MacArthur Lake Stormwater Capture Project Final Environmental Impact Report

Prepared for
City of Los Angeles

Prepared by
**CDM
Smith**

6. Figure 2-11 of the Draft EIR is hereby revised to reflect the revised staging areas. Please see the following revised figure.

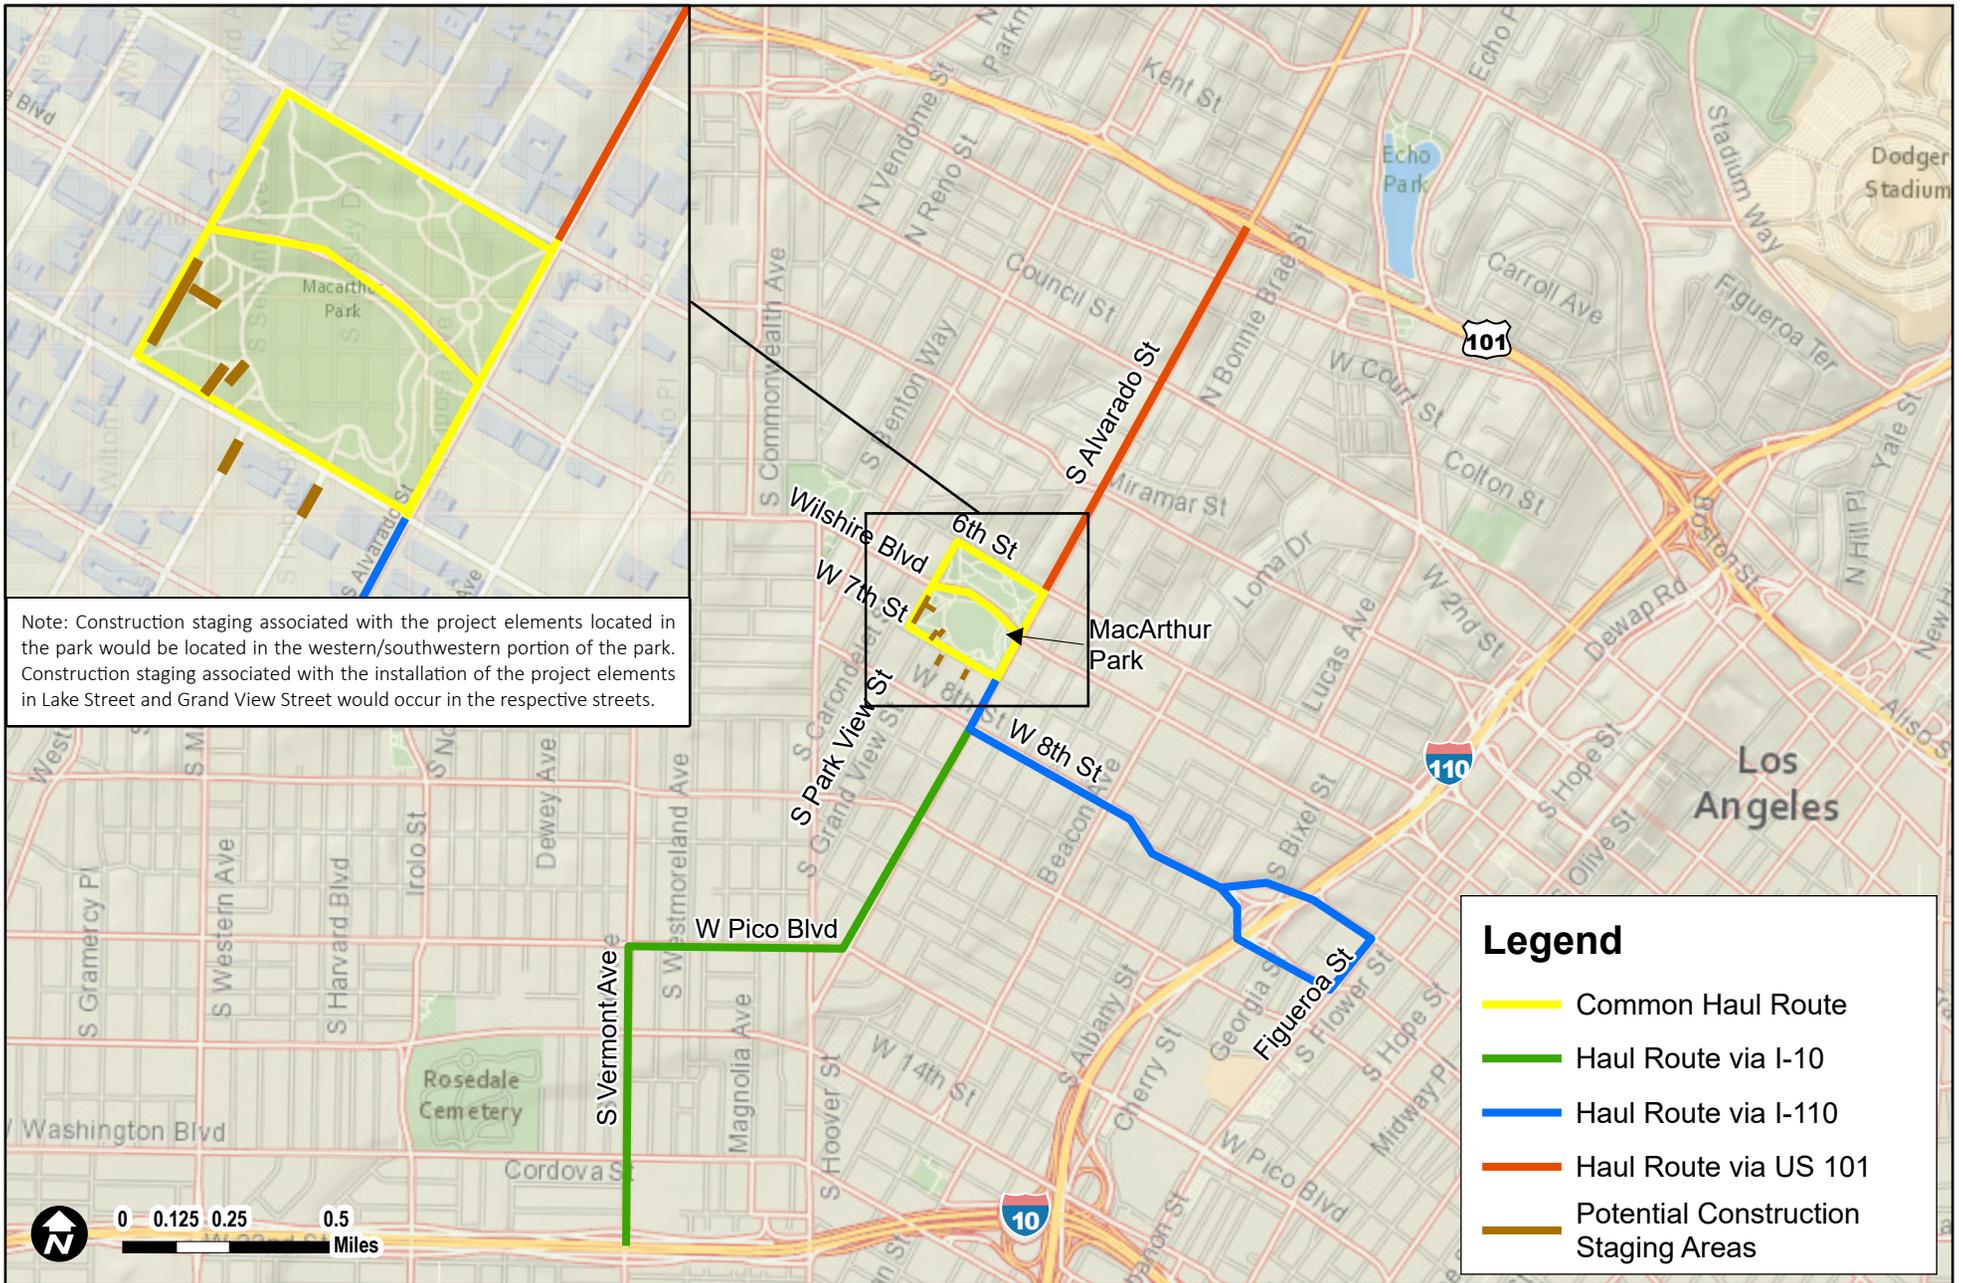
The comment is related to language in Section 2.6.1 of the Draft EIR. RAP concerns regarding the use of park space for construction staging are noted. Subsequent to submittal of this letter, BOE, LASAN and RAP met on April 24, 2025 and agreed that it would be most efficient to conduct staging within the park. Construction would proceed in a phased manner, limiting the extent of fencing and minimizing disruption to park users to the extent feasible. Staging within the park would be conducted in three phases. During active construction of any one phase, the remaining two phased areas would be open to the public to the extent feasible to maintain public safety. In addition, access to the recreational playground and park entrances would be maintained throughout construction. The staging areas would be clearly delineated and fenced to maintain public safety throughout the construction period and would include tree protection zones in accordance with RAP guidelines. No additional areas of the park would be used for construction-related activities outside of those directly associated with the approved park improvements. Any park-adjacent staging areas would be limited to activities supporting park improvement work only. The contractor would be responsible for securing their own laydown space, whether within the adjacent staging areas or offsite, for the storage of equipment, materials, and spoils associated with the street improvement scope.

To provide clarification, page 2-23 and Figure 2-11 of the Draft EIR have been revised. Please see Chapter F3, *Revisions, Clarifications, and Corrections to the Draft EIR*.
